E. Conway
File No: SP15-011783

TO:	CHAIR AND MEMBERS – PLANNING & ENVIRONMENT COMMITTEE
FROM:	GEORGE KOTSIFAS, P.ENG MANAGING DIRECTOR, DEVELOPMENT & COMPLIANCE SERVICES & CHIEF BUILDING OFFICIAL
SUBJECT:	APPLICATION BY: CITY OF LONDON 165 ELMWOOD AVENUE EAST PUBLIC SITE PLAN MEETING MAY 19, 2015

Date Application Accepted: April 8, 2015	Agent: City Of London – John Devito – Manager of Facilities Design and Construction
REQUESTED ACTION: An application for Site Plan Approval to permit a building addition with associated parking, access and servicing works.

Site Plan

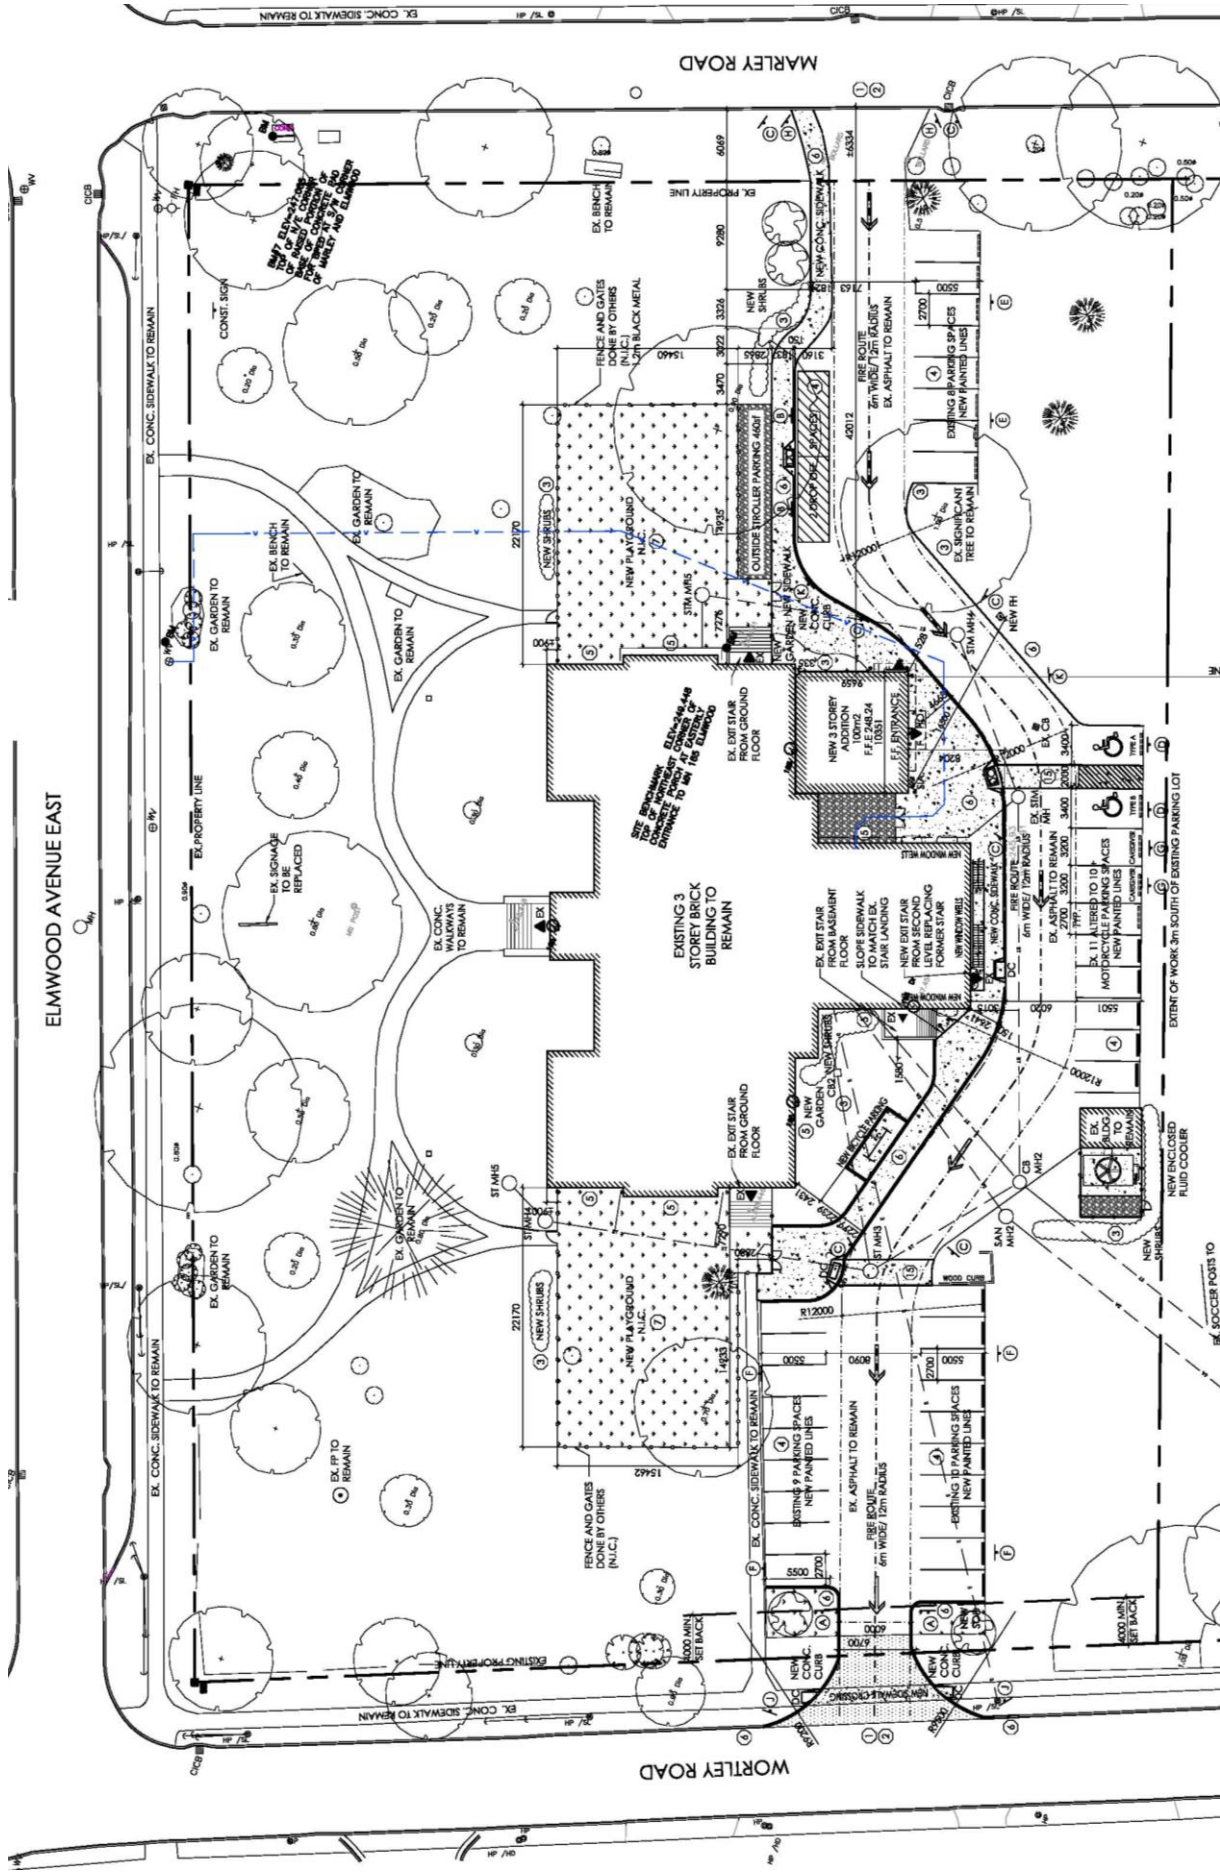
- 6.0m clear throat recommended for proposed access onto Wortley Road
- Utility poles and street lights are a minimum of 1.5m away from proposed access to Wortley Road
- If the on-site vehicle flow is to be one way appropriate signage and pavement markings will be required (one way arrows, no entry signs painted left out/right out)

The proposed 1.3 m walkway width associated with the new entrance does not meet a minimum 1.8 m width accessibility standard. Numerous pinch points at building walls and parking lot curbs make for an unsafe and unpleasant situation.

The landing around the new main entrance could be expanded beyond a minimum 1.8 metres to 2.5 metres to function adequately as a building entrance to a universally accessible community building, especially adjacent to a vehicle driveway.

The proposed bicycle parking area is a good idea though it could be covered.

The existing symmetrical walkway system from Elmwood should be maintained, however, the east and west, north-south sections parallel to the building have been interrupted by proposed playgrounds. Those fenced and gated playgrounds will be open to the public when not in use for YMCA programs allowing passage through the

playground to the east-west walkway connecting to the new main entrance. When the playgrounds are in use, however, there would be no north to south access to the new entrance from the existing walkways.

For example, a walkway could be provided around the playgrounds or the playgrounds could be disconnected from the building allowing for the continuation of the existing north-south walkways to the proposed east-west walkway and thus the new main entrance.

Any pedestrian crossing of a roadway should be perpendicular to the roadway.

The necessity for the vehicle driveway to serve fire vehicles is understood. In relation to that the required centre-line radius is 12 metres. A 7.5 metre driveway is unnecessary; 6 metres would suffice and result in less asphalt and thus impermeable surface while also contributing to traffic calming and thus safety.

A significant existing tree on the west side of the site adjacent to Wortley Road is shown to have been removed with no explanation.

Staff Response: While we generally agree with the above comments provided by the Urban Design Peer Review Panel as it relates to the entire property, staff have been requested to look at a redevelopment relating to a small portion of this site. The proposal meets with the City’s Site Plan Control By-law; will meet the Zoning by-law (upon approval); has been vetted through the Ontario Heritage Trust and through our own Community Planning and Design staff and is deemed acceptable. Staff have also worked with the applicant to try and address many of the comments raised by the Panel as it relates to access to playground areas, pedestrian pathways, landscaping, etc. It should be noted that the City will be commencing a separate public engagement process regarding the large open space to the south (commonly referred to as the “Village Green”) in the coming months and many of the above noted issues raised by the Panel will also be considered through that process.

Landscape Plan

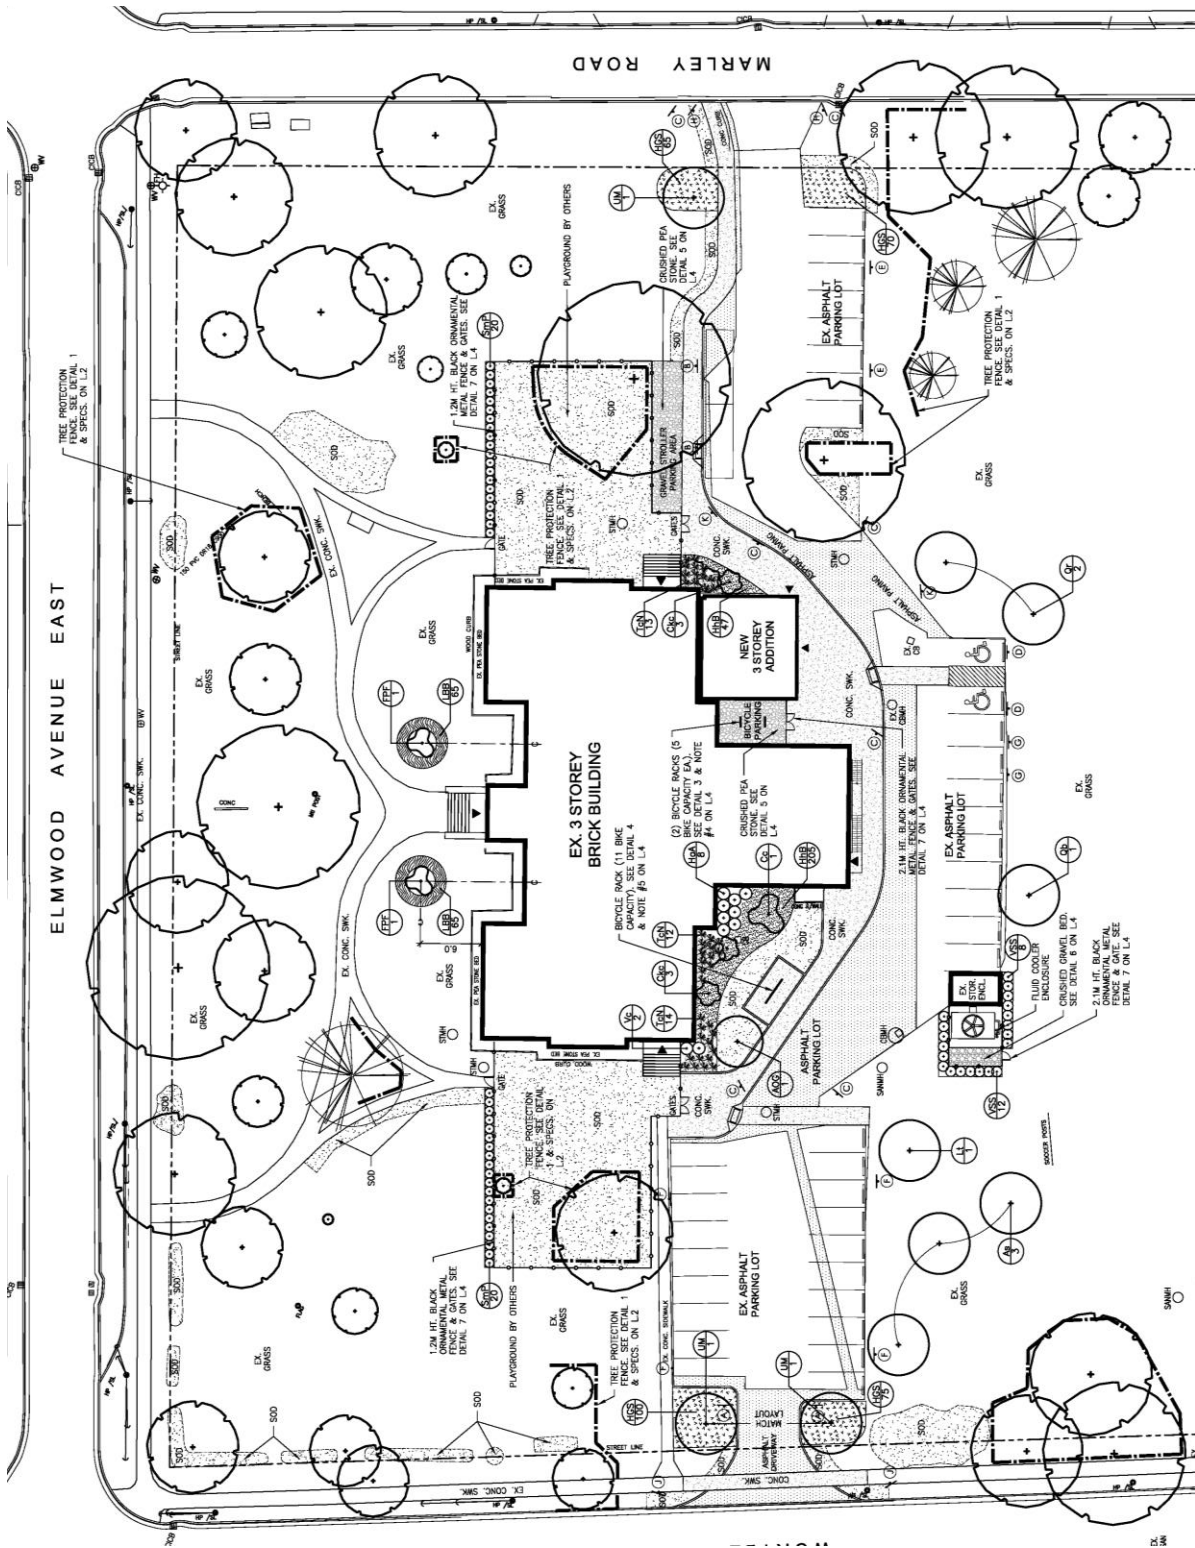
There is no proposed landscape design so the existing building and proposed additions are neither effectively enhanced, nor is there a blending of new, existing and future development and the screening of proposed parking areas from adjacent properties and streets as required by London’s Official Plan - 11.1.1.x Landscaping.

Sod alone is not an appropriate surface for such a high-use playground.

An existing, newly-replanted memorial tree in the west playground area would have to be protected or relocated.

A comprehensive landscape plan for the whole block is required. Given the proximity of the green and its new status as a city park and the cultural heritage and area of the landscape east, west and north of the building, it would be appropriate to think of the whole block as a public park landscape that contains a beautiful building. That would also justify a more contextually relevant design for the vehicle facilities as noted above.”

Elevations

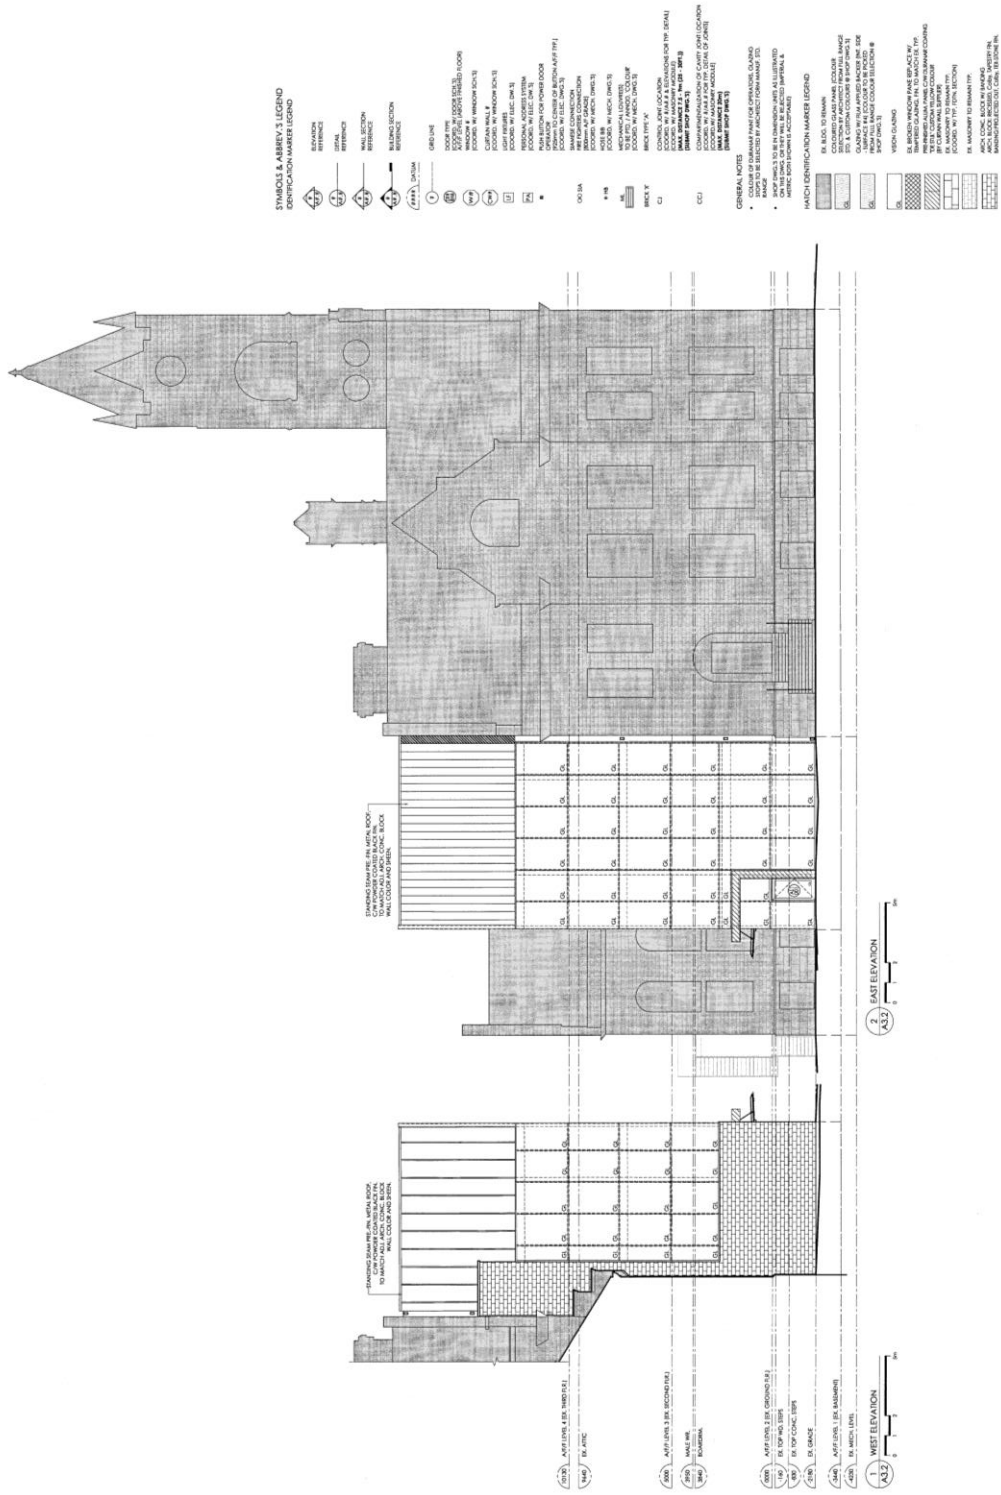
The Trust supports both the location and the massing of the proposed addition. While we have some concerns with respect to the size of the addition, it is our understanding that given the City's current accessibility requirements it is not possible to reduce the size and still meet these requirements. The addition does not exceed the height of the main building and the use of new materials will allow the new work to be distinguishable from the old. The addition is to be clad in glass and brick with the glass helping to form a clear visual break from the historic building. The modern brick will be different from the historic brick on the London Normal School and while a colour for the brick has not been chosen the Trust prefers something that contrasts but compliments the existing ochre coloured brick would be suitable.

The drawings indicate brick will be used to clad a portion of the west and south sides of the addition. The inclusion of the brick has added some visual interest to what was once presented as more of a glass-box addition. It should be noted that given the extensive use of glass on this south-facing addition cooling this space in the summer months could provide costly and difficult. The addition of brick is seen as helping with this issue and while the east portion of the addition currently does not contain any brick it is possible that this may change while the details of the design are being worked out. The Trust feels agrees that the use of both glass and brick for the addition is appropriate.
